PRODUCT & ENGINEERING BULLETIN

86651 Fuel Filter Product Replacement for Davco Fuel Pro 380 & 382

#99-5 5-19-99 Wix HD

Part # 86651

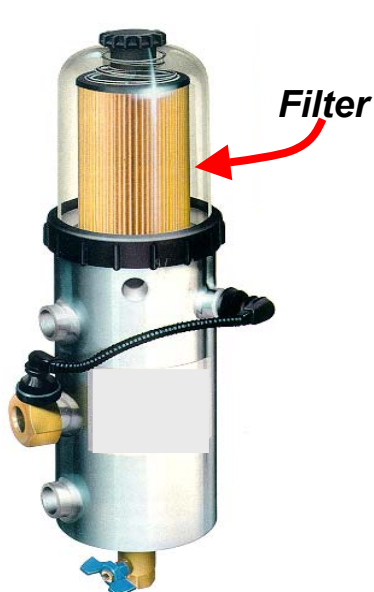
New Grommet on
CARQUEST Filter's 86651
will fit all applications of
Davco Fuel Pro 380 & 382.

CARQUEST Filter 86651 is the Filter
replacement for Davco Fuel Pro 380 & 382. A
new grommet has been developed to fit both the
Cummins/Cat and Detroit applications,
eliminating the need for stocking two filters.
